PLAN AND ZONING COMMISSION MEETING

CITY OF DAVENPORT, IOWA

TUESDAY, NOVEMBER 30, 2021; 5:00 PM

Case P21-05: Request of Beckett Place Development, LLC on behalf of Glen and Kathleen Moeller for a Preliminary Plat of Beckett Place for a 51 lot subdivision on 25.8 acres located south of Veterans Memorial Parkway and east of Interstate 74. [Ward 6]

PRELIMINARY PLAT BECKETT PLACE DAVENPORT, IOWA

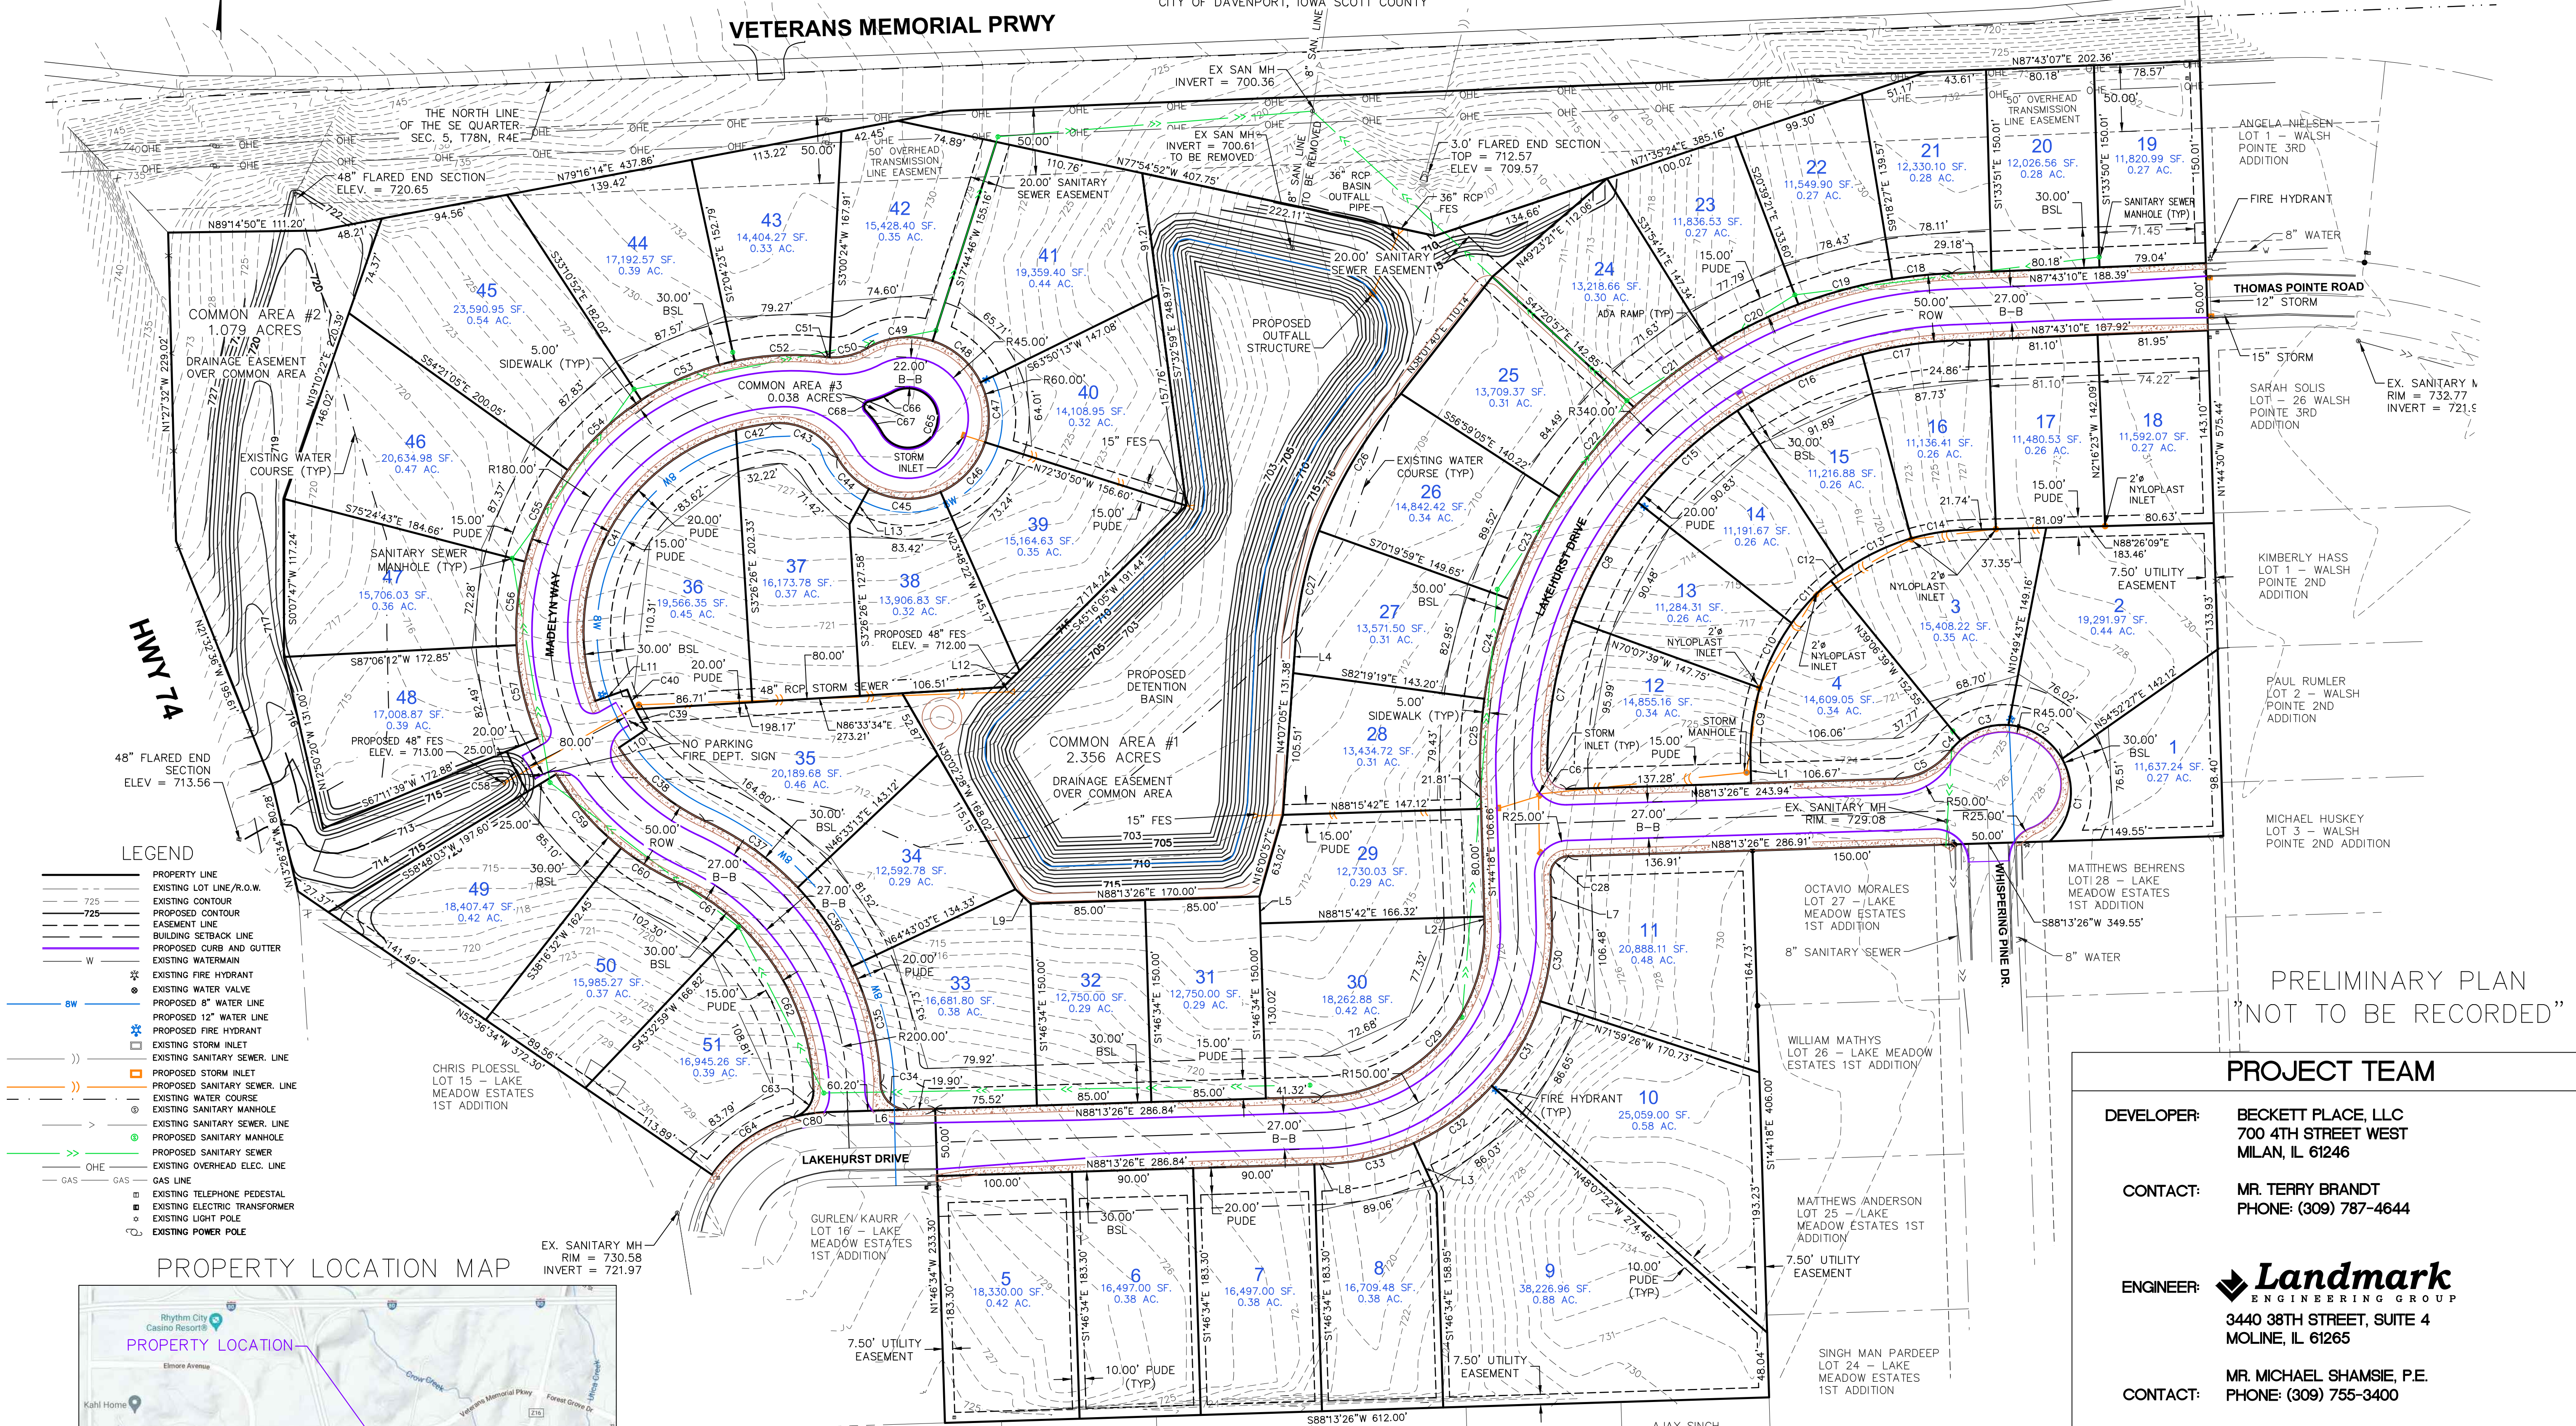
1. Madelyn Way shall be renamed to Madelyn Court.
2. A variance to Section 16.24.040C for a cul-de-sac exceeding maximum length is granted for Madelyn Court.

3. Standard Plat Notes shall be added.
4. The new street connecting the existing Lakehurst Drive to Thomas Pointe Road shall be renamed to Thomas Pointe Road throughout the entire subdivision.

5. A street name is required for the east-west roadway connecting Lakehurst Drive to Whispering Pine Drive.
6. On-street parking shall be limited to one side of the street. No parking will be permitted within the cul-de-sac.

7. Remove the island from the Madelyn Court cul-de-sac.
8. Remove the Madelyn Court mid-block turn around as public right-of-way and maintain a 50 foot width. The hammerhead turnaround does not meet the requirements of the International Fire Code.

9. Add the following note to the plat, "Acceptable sewer size and drainage easement width depend upon pipe depth and storm water flows. Until construction plans and stormwater calculations are submitted and approved, sewer size and easement widths are to be considered as preliminary only and may change with final platting."

10. Shift the right-of-way line on lot 5 to the south to align with the north property line of 6325 Lakehurst Drive. The entirety of the sidewalk shall be located within the public right-of-way.

11. Add a note stating, "Sidewalks shall be constructed along all street frontages prior to the completion of residential construction for each lot, or as so ordered by the City of Davenport."

12. All easements shall be a minimum width of 15 feet.
13. Label the easement between lots 24 and 25 as "20' Sanitary Sewer, Utility, and Access Easement"

1. Streets: The standard specifications call for parking on only one side of the street where street width is 27 feet or less. Madelyn Way will need to be renamed to Madelyn Court and Lakehurst Drive must be renamed to Thomas Pointe Road. Sidewalks are required along all city right-of-way. Staff is recommending the landscape island within the Madelyn Way cul-de-sac be removed. Islands create challenges with snow plowing and general maintenance operations. The existing right-of-way on Lakehurst Drive is 55 feet wide. A more gradual taper is required. The western corner of the front lot line of Lot 5 must align with Lot 16 of Lake Meadow Estates 1st Addition.

2. Storm Water: The site requires stormwater detention and shall meet water quality criteria in the Iowa Storm Water Management Manual. Storm detention is proposed in Common Areas 1 and 2, which should be relabeled as outlots. Access must be provided for maintenance of detention areas and any drainage ways must be maintained to provide for the proper flow of water. The full extent of the trail must be located within an access easement.

5. Other: This is an urban area and normal utility services are available. The public utility easement must be increased to 20 feet where water mains are planned. The fire department does not require the hammerhead turnaround midway through Madelyn Way.

CHEDDAR'S 2ND ADDITION

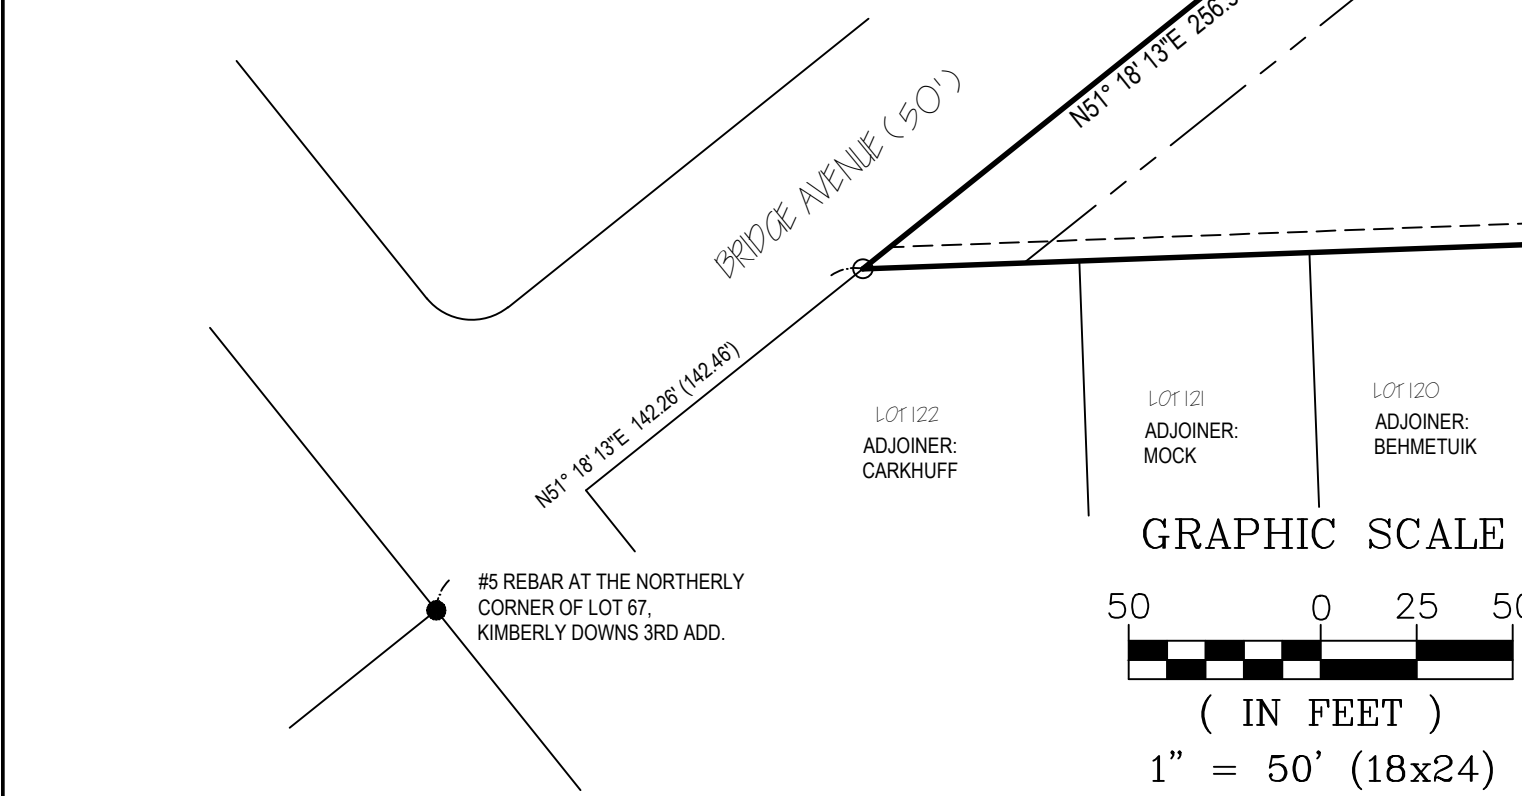
4. Revise note #7 to state, " The subject property is zoned C-2 Corridor Commercial District."
5. Remove the "(25') Building Setback Line" along Bridge Avenue.

6. Add 15 foot utility easements on the frontages of Bridge Avenue and East Kimberly Road.
7. The 15 foot utility easement on the east end shall also be a sewer easement. Extend this same easement north to East Kimberly Road.

8. Revise comment #9 to state, "Stormwater detention and water quality treatment may be required with future development in this subdivision per governing ordinance."

9. Add a note stating, "A landscape buffer yard shall be installed upon development in accordance with Section 17.11.080 of the Zoning Ordinance where lot lines are adjacent to single-family or two-family zoning districts."

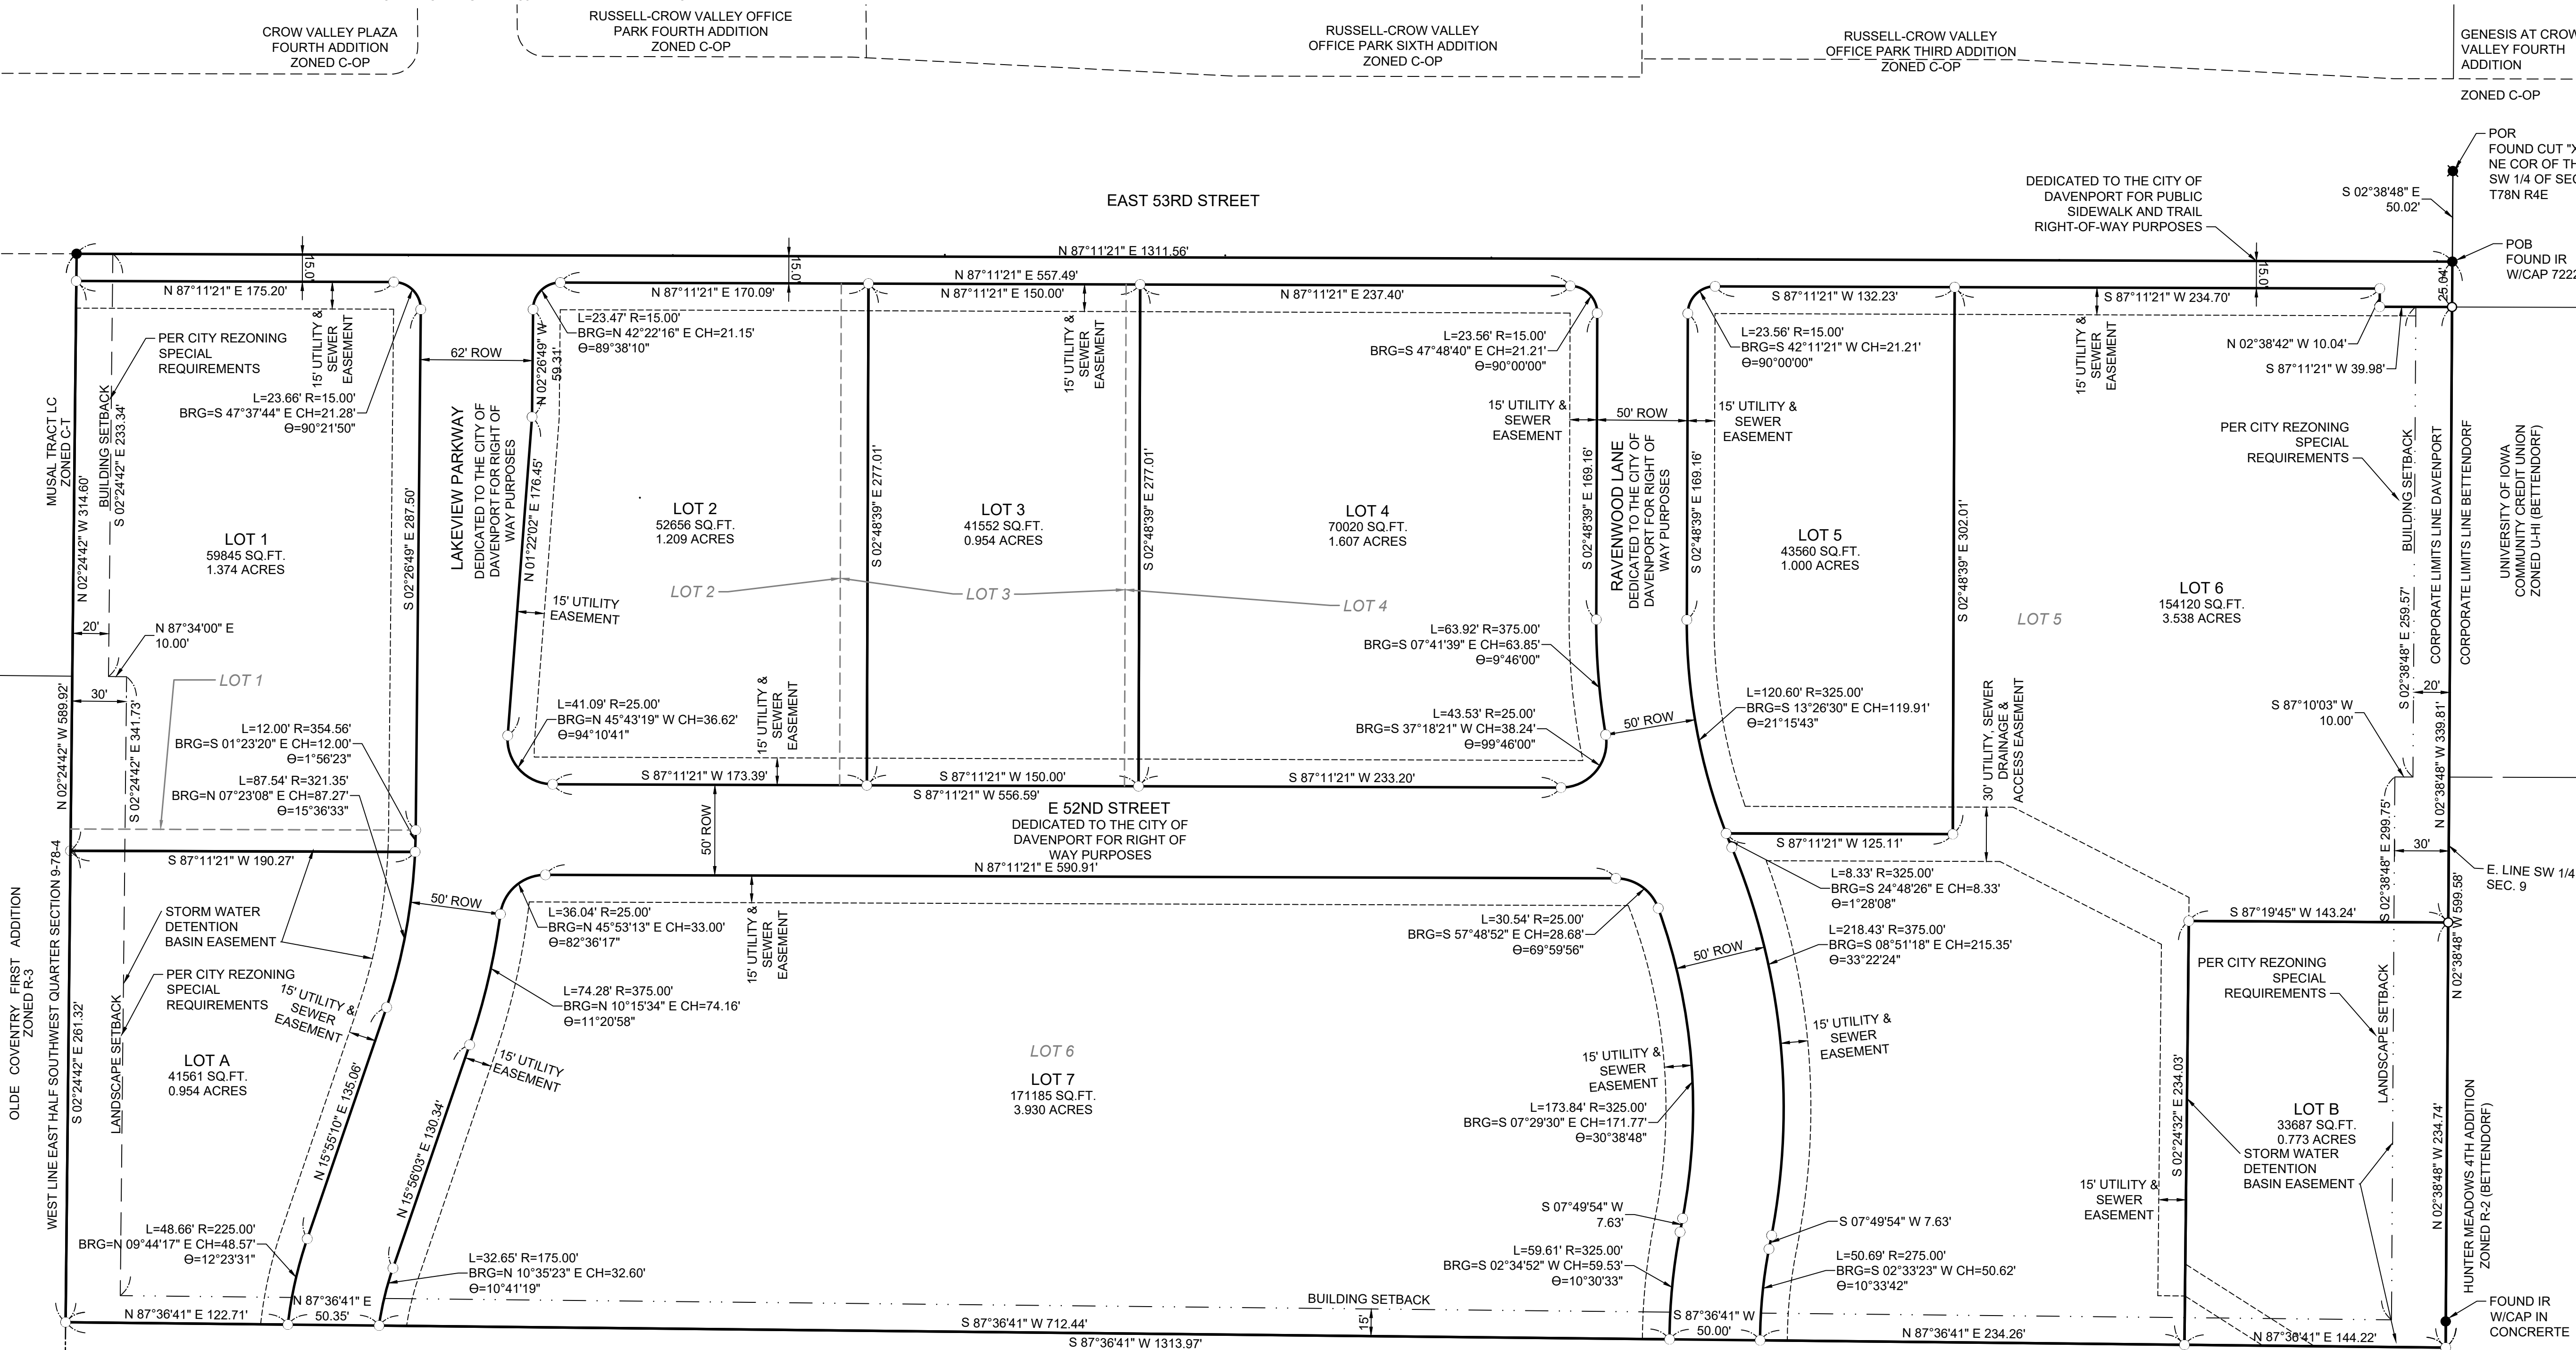
1. That the surveyor signs the plat.
2. That the utility providers sign the plat when their easement needs have been met.
3. Include a note stating, "The sidewalk along East 53rd Street shall be constructed as a ten foot wide trail."
4. Provide the following note, "The access location to lot 5 from Ravenwood Lane shall be no closer to East 53rd Street than the East 52nd Street intersection."
5. Provide an access easement along the south lot line in Lot 1.
